CHATHAM COUNTY PURCHASING & CONTRACTING DEPARTMENT

ADDENDUM NO. 2 TO 20-0027-5

FOR: COOLING TOWERS REPLACEMENT AT CHATHAM COUNTY DETENTION CENTER

Cooling Towers

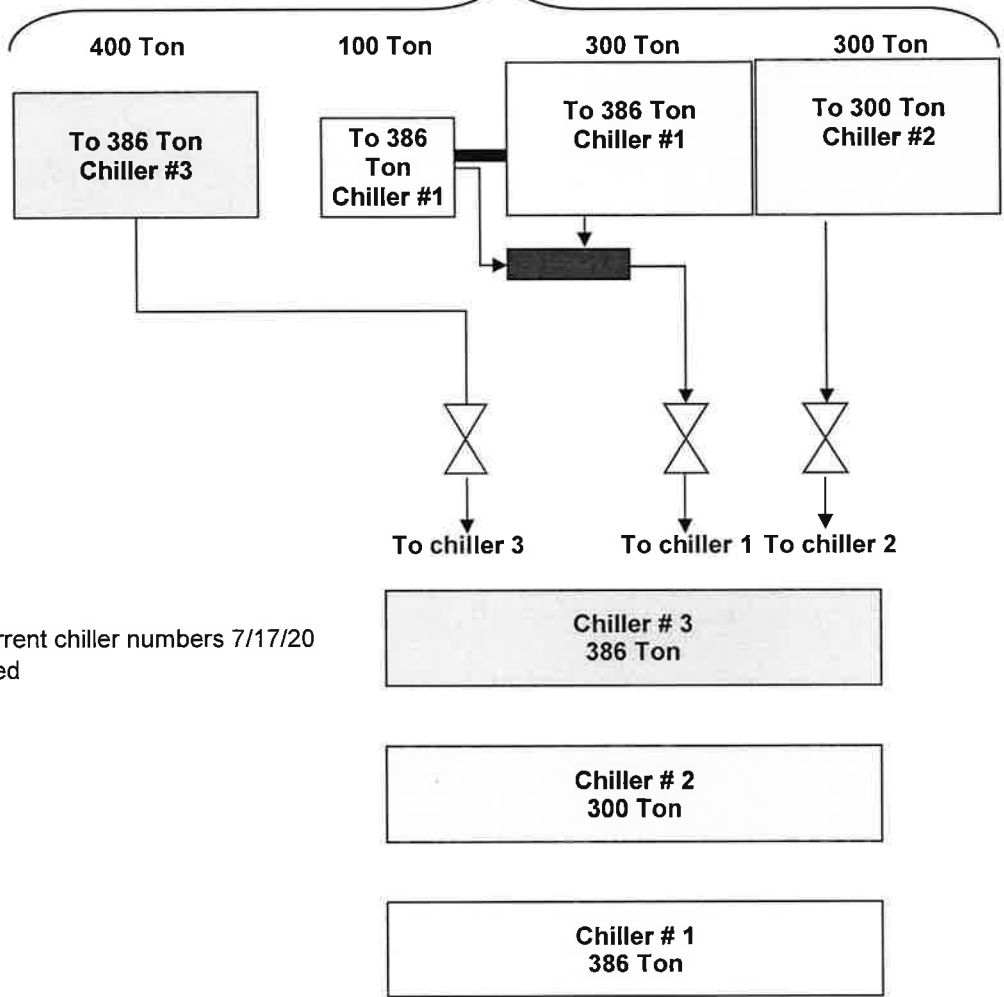
3.Q) Does one of the existing chiller/cooling tower arrangements has sufficient capacity for conditioning the facility, if so, define which one and can it be used for conditioning during the cooling tower replacement, or will a temporary chiller be required.

Updated to show current chiller numbers 7/17/20
One and two switched

A) Attached to this addendum is a layout showing the cooling towers and chillers again 1 of the 386t must remain active. As you can see by the drawing chiller 3 can stay active while the twin cooling tower and the small cooling tower is removed.
